Table 68.310-1

Rationale for Harmonized Requirement:

§ 68.312 On-hook impedance limitations.

(Reworded and Changed)

Table 68.310-2
Frequency Ranges of Transverse Balance
Requirements for Digital Services

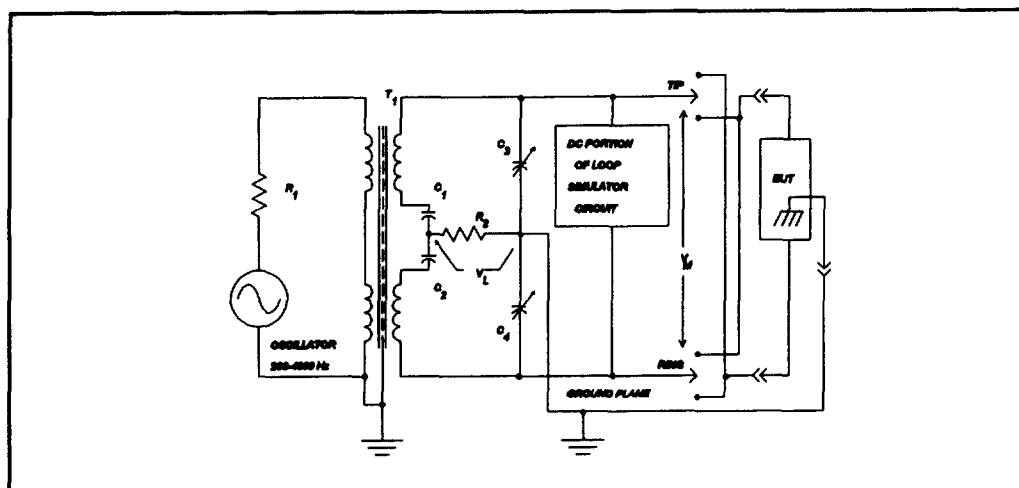
For digital equipment, two technical changes were made. First, the 40 dB limit from 12 kHz to 15 kHz has been reduced to 35 dB. This makes the 12 kHz breakpoint consistent with the longitudinal impedance specification change from 500 Ohms to 90 Ohms in Section 68.308 and in this section. The reduction in this requirement will not increase the probability of harm. The second change is in the 1.544 Mbps requirements where the lower frequency limit has been changed from 200 Hz to 10 kHz. This change was made because (1) there is little energy in the 1.544 Mbps signal below 10 kHz which can cause crosstalk interference and (2) measurements below 10 kHz require a lot more care and changes in circuitry. Thus it was concluded that there is little benefit from addressing the balance below 10 kHz for 1.544 Mbps equipment under test.

Certain additional subrate services have been added to the rules (namely, 3.2 kbps, 6.8 kbps, 12.8 kbps, 19.2 kbps, 25.6 kbps and 72 kbps.) The additional subrate services are secondary channel services except for 19.2 kbps and 72 kbps which are new subrate services. The additions complete the requirements for all the current subrate services.

Digital Service	Frequency Range	Longitudinal Termination	Metallic Termination
2.4	200 to 2.4 kHz	500	135
3.2	200 to 3.2 kHz	500	135
4.8	200 to 4.8 kHz	500	135
6.4	200 to 6.4 kHz	500	135
9.6	200 to 9.6 kHz	500	135
12.8*	200 to 12.8 kHz	500/90	135
19.2*	200 to 19.2 kHz	500/90	135
25.6*	200 to 26.6 kHz	500/90	135
56*	200 to 56 kHz	500/90	135
72*	200 to 72 kHz	500/90	135
1.544	10 kHz to 1.544 MHz	90	100

* Note: For 200 to 12 kHz the longitudinal termination shall be 500 Ohms and above 12 kHz the longitudinal termination shall be 90 Ohms.
